WORKSHOP AGENDA

Planning Commission

September 16, 2025 @ 5:30 PM

SHEET NO. C2.01

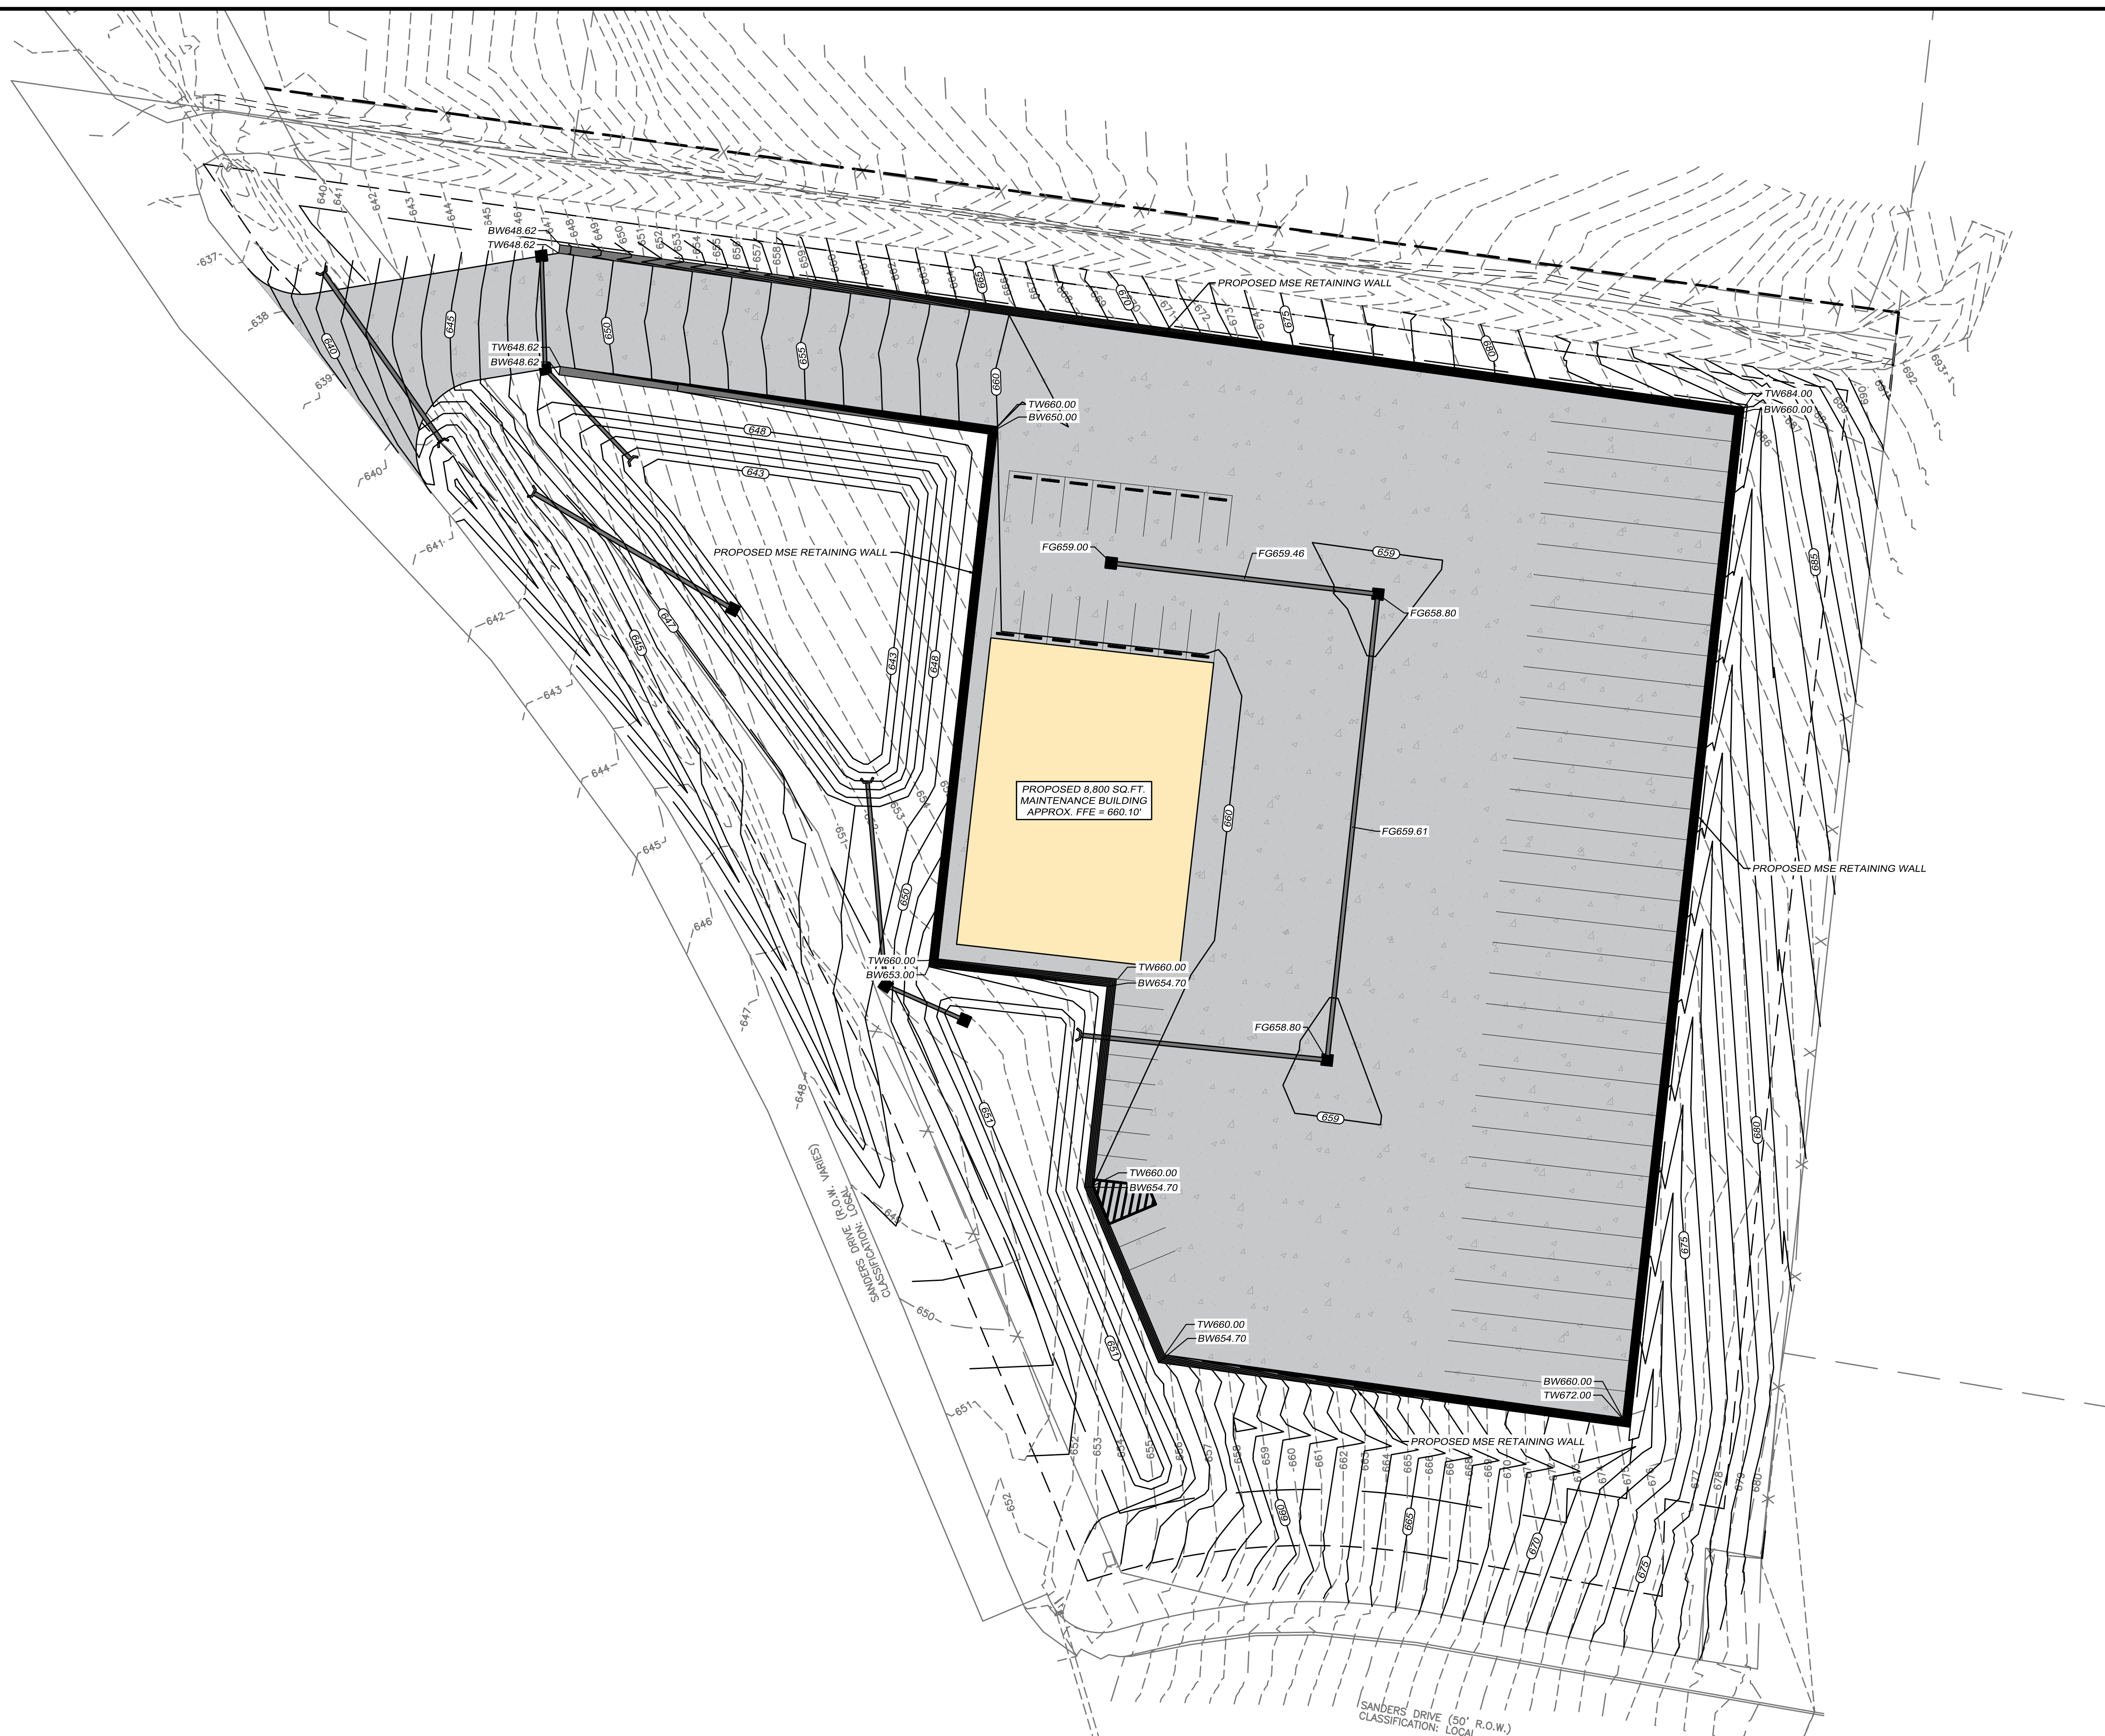
8. (Sheet C2.01) Show distances from two perpendicular boundaries to the building so that the building can be located in the field.
9. (Sheet C2.01) Show lane striping for entry drive.

16. (Sheet C2.01) Provide ADA accessible spaces as required
17. (Sheet C2.01) Question: Is a monument sign proposed at the road? If yes, please show location and size.

32. (Sheet C2.01) Show far side edge of pavement for Mason Road and show edge of [pavement for Tech Park Drive
33. (Sheet C4.01) Show size, material, and invert elevations of existing pipe under the access drive along the North boundary

46. Provide a Site Profile from the centerline of Mason Road and following the centerline of the driveway to the nearest point of the building.
47. (Sheet C2.01) Show five-foot wide sidewalk along all public road frontages

48. (Sheet C2.01) Show dumpster pad or provide a narrative explaining how waste will be handled without a dumpster.
49. The City specifications have required General Notes. These must be included. They can be found at: <https://www.lavergnetn.gov/DocumentCenter/View/4671/Permitting-and-Construction-General-Information-and-Requirements>

SHEET NO. C4.01

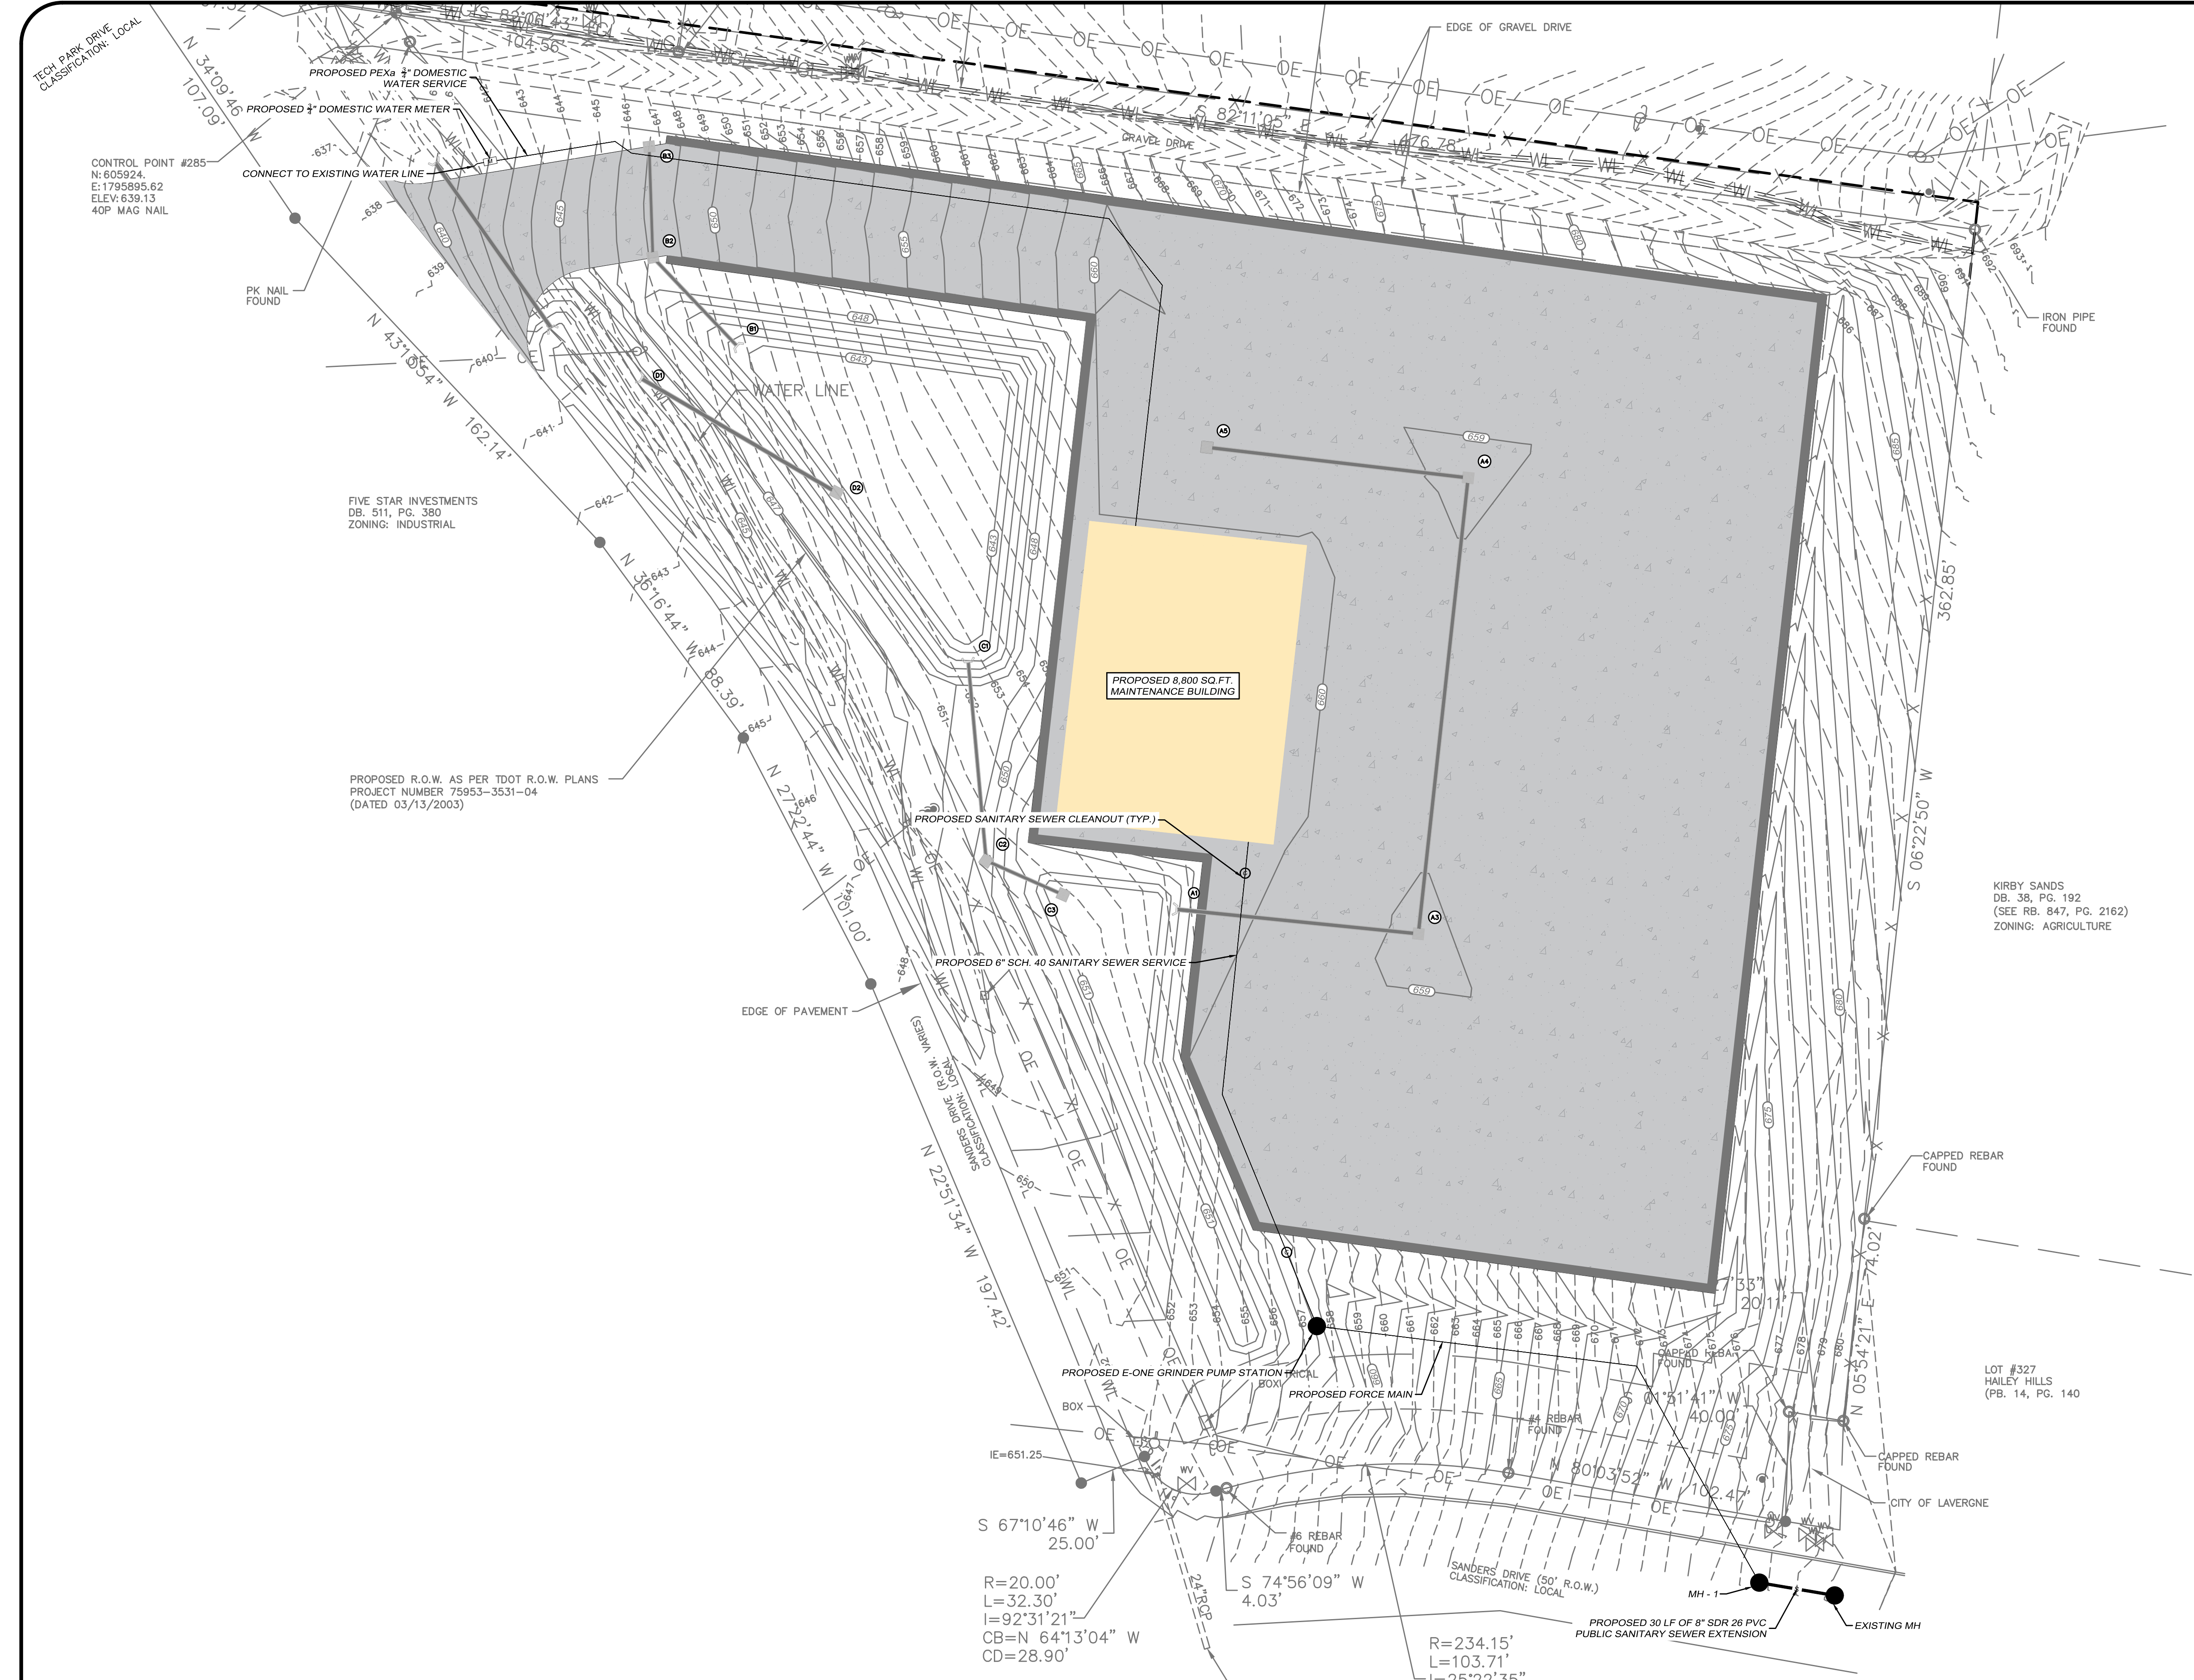
18. (Sheet C4.01) Ditch B south of parking area flows along a nearly 8% in slope. Maximum flow velocity for Curlex blanket is 7%. Provide a more robust ground cover in that section of Ditch B.

19. Provide all calculations required by the La Vergne Stormwater Management Ordinance including stormwater quality and stormwater quantity.
20. (Sheet C4.01) In the western end of Ditch B where it outflows into the bioretention pond, provide riprap or other similar protection where the ditch slope flattens out into the pond.

21. (Sheet C4.01) Provide erosion protection from the outfall of Storm Line D down to the flowline of Ditch A.
22. (Sheet C6.03) Provide a note that all EPSC controls shown on this sheet are permanent.

23. (Sheet C4.01) Provide a swale along the top of the retaining wall along the north edge of the parking area and provide a detail for the swale.
24. (Sheet C4.01) Provide details showing how the outlet control structures will be constructed which match the calculations.

25. (Sheet C4.01) Provide hydraulic calculations for pipes as required by Stormwater Management Ordinance
26. Provide construction details for catch basins, headwalls, pipe trenching, etc.

27. (Sheet C4.01) Show how bypass Q is going to be avoided at catch basins B2 and B3.
28. (Sheet C4.01) For all pipes, catch basins, and headwalls, show pipe size, material, invert elevations, and top of casting elevations.
